Reference: Possible Reportable Defect 10CFR21
Component: Robertshaw Controls Company
Temperature Control Valve Models 1284 & 1825
Size 5" & 6"

Attached is a copy of a letter from the Robertshaw Controls Company dated May 13, 1982. The nut referred to is shown on the attached partial drawing N84984-F3.

This letter is to inform you of an incident involving a Robertshaw thermostatic valve supplied for use at a nuclear power plant. This information should be evaluated by the criteria set forth in Title 10 of the Code of Federal Regulations Part 21 (10CFR21).

DETAIL 1

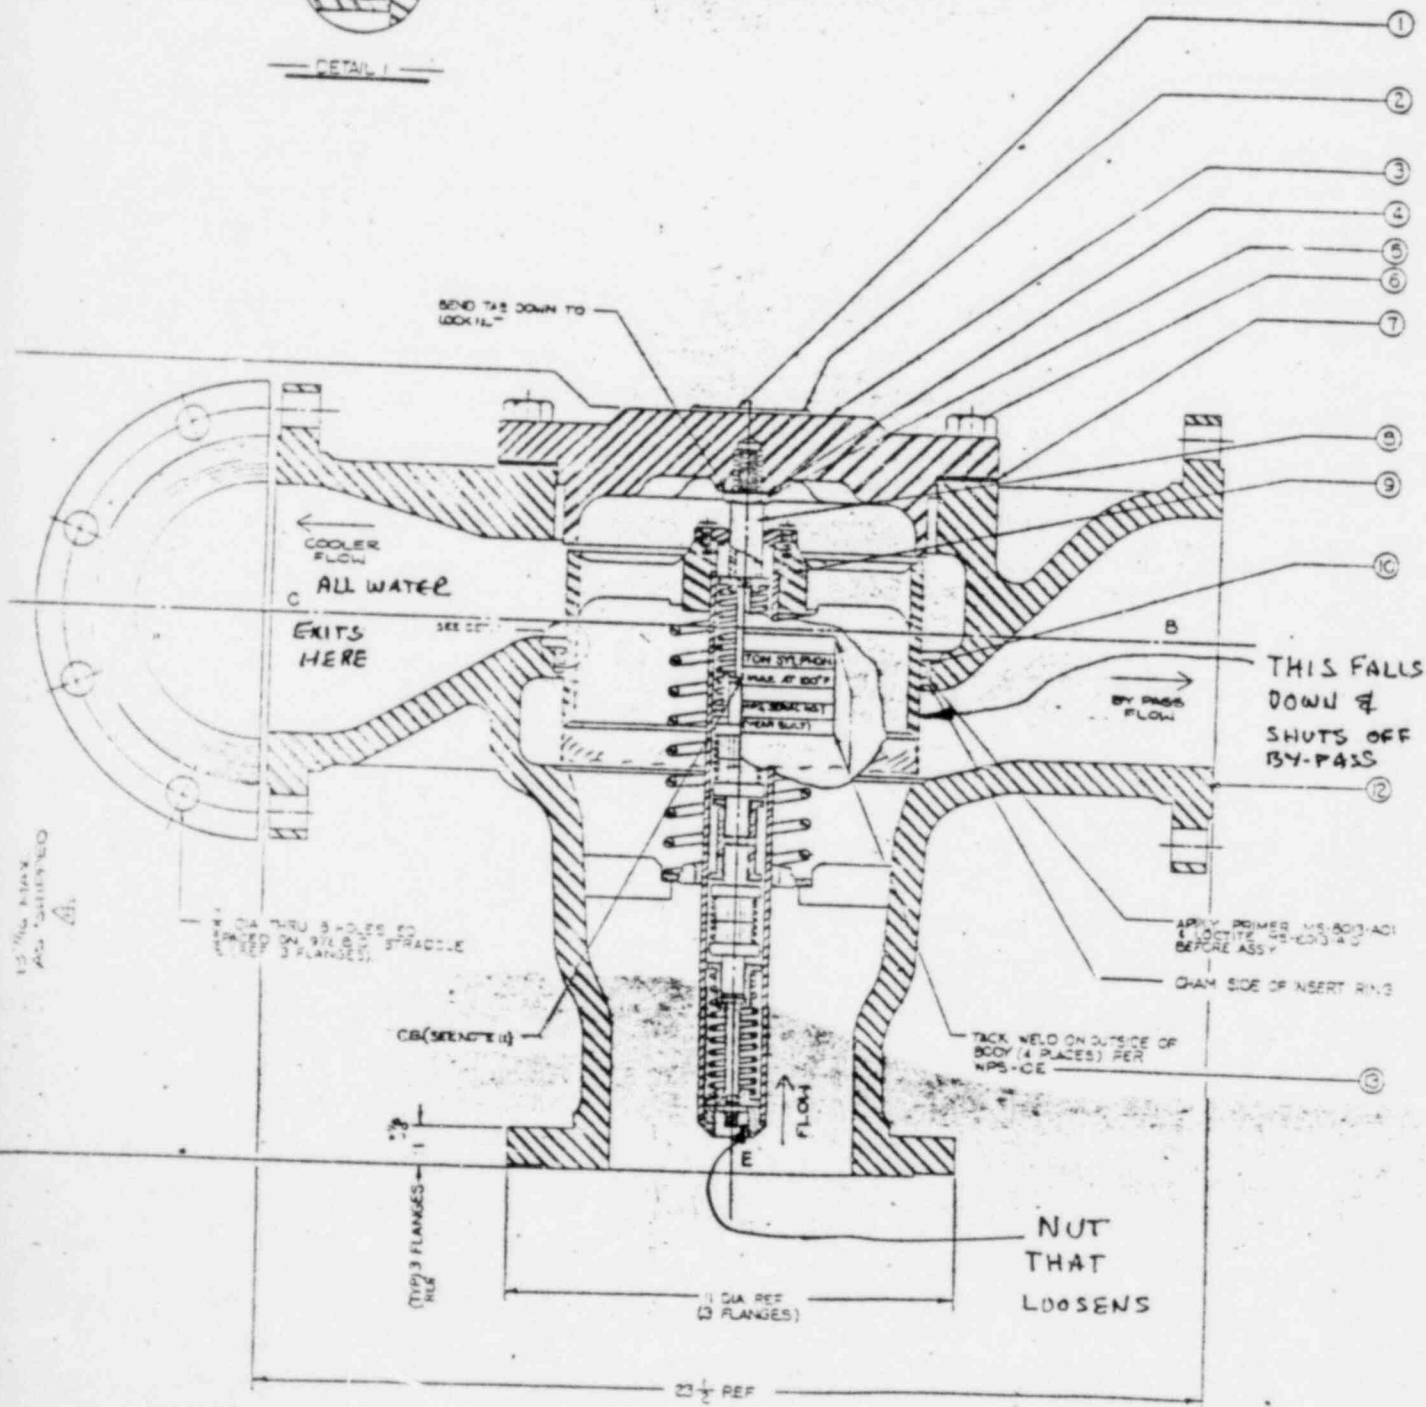
In the Fall of 1977, it was reported to us that the nut had completely "backed off" in one valve intended for nuclear service. This allowed the valve to go into the full cooling position. At that time the design of the overrun assembly called for the nut to be staked in place. The design was revised to require soldering the nut to the bolt. No further reports were received of any difficulty.

Our investigation following the report from the Virgil Summer site disclosed that the design change made in 1977 was a "USE" change, i.e., completed overrun assemblies and completed thermostatic valve assemblies were "used" before the design change was implemented. These overrun assemblies are also used in commercial valves, and it is impossible to determine how many, if any, assemblies with the staked construction were supplied to nuclear power plant after the design change was made.

In our investigation, we also discovered that at least one lot of overrun assemblies for the 5" size valves had been placed in our stock without solder locking the nut in place. Again, since this is also used in commercial valves, we cannot determine if any of this group was actually supplied to you for use at a nuclear power plant site.

DRIVE INSERT LIP INTO RETAINING GROOVE
8 PLACES MIN. EQ. DISTANCE APART
AN 8T32 PLUS GAGE MUST GO THRU
INSERT AFTER STAKING
